CV2306
CV2307

Specification AD/CV2306, CV2307 Issue No. 3 dated 19.11.57 To be read in conjunction with K1001 and BS1409	SECURITY	
	Specification	Valve
	Unclassified	Unclassified

TYPE OF VALVE: Broad-band T.R. Valve

AMENDMENT No.1.

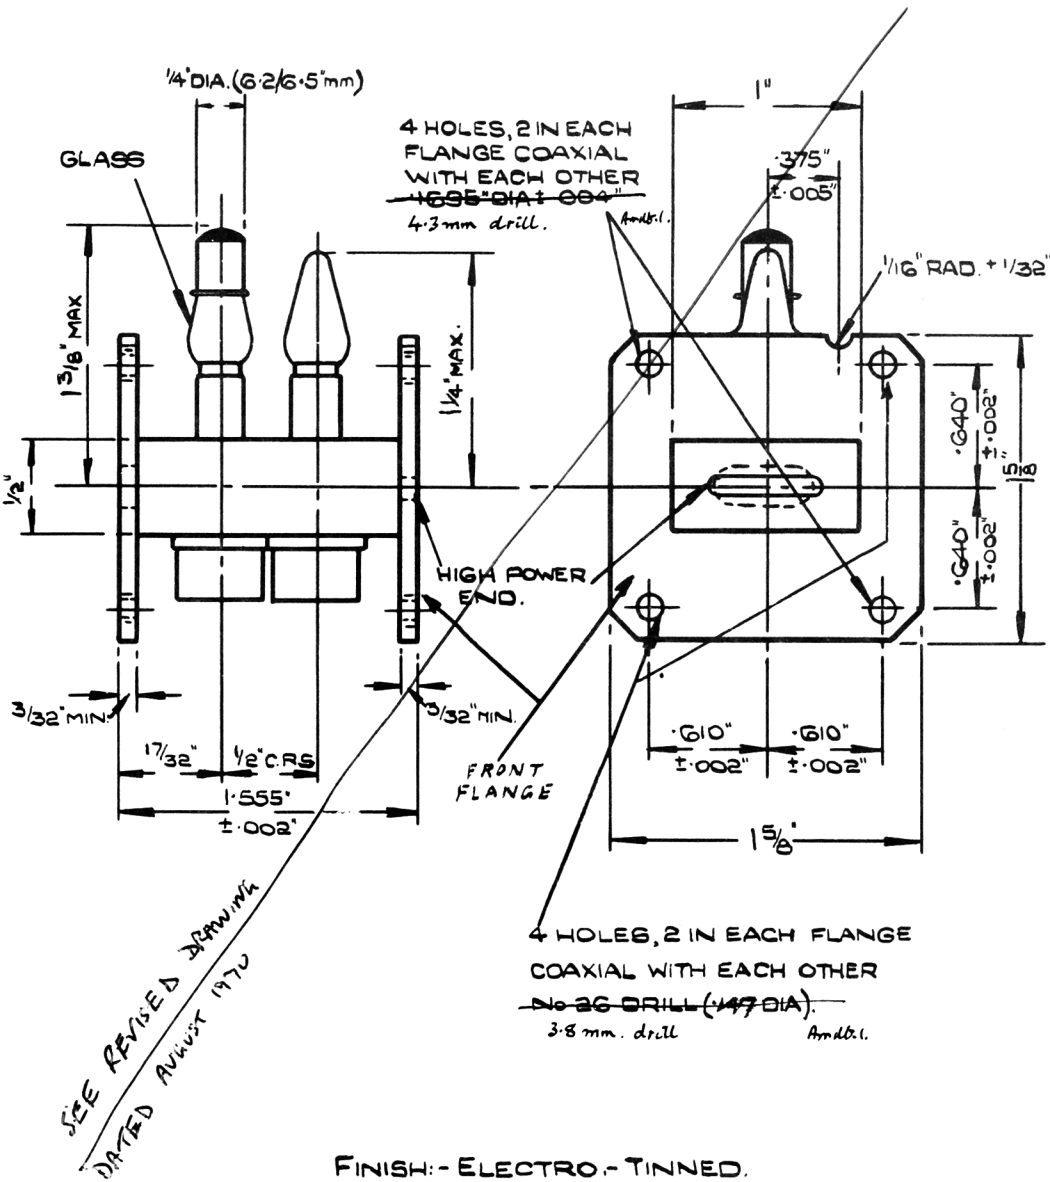
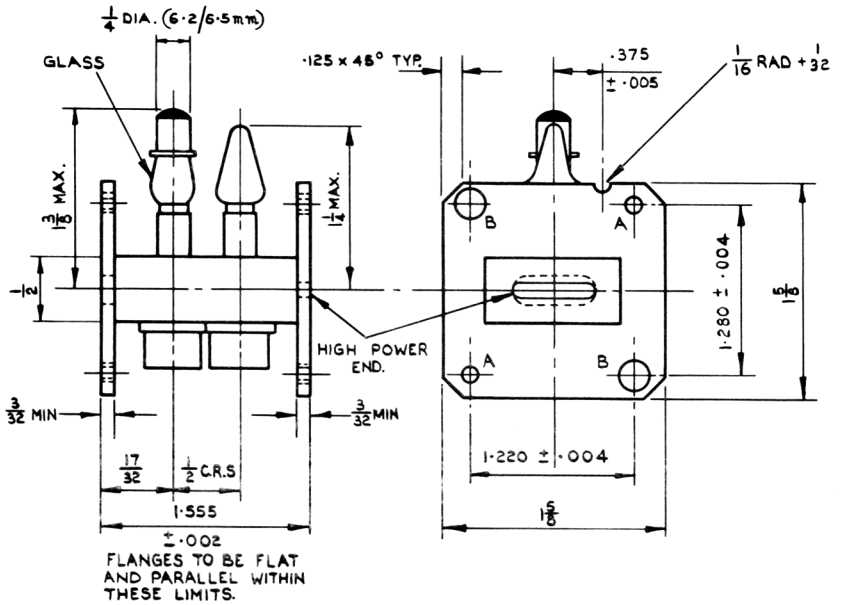
Page 6. In the two Notes referring to the flange holes:-

(i) Delete '.1695 "dia ± .004"' and substitute '4.3 m.m. drill'

(ii) Delete 'No.26 Drill (.147 DIA.)' and substitute '3.8 m.m. drill'

'A' HOLES 3·8mm DRILL – 2 IN EACH FLANGE COAXIAL TO EACH OTHER
'B' HOLES 4·3mm DRILL – 2 IN EACH FLANGE COAXIAL TO EACH OTHER
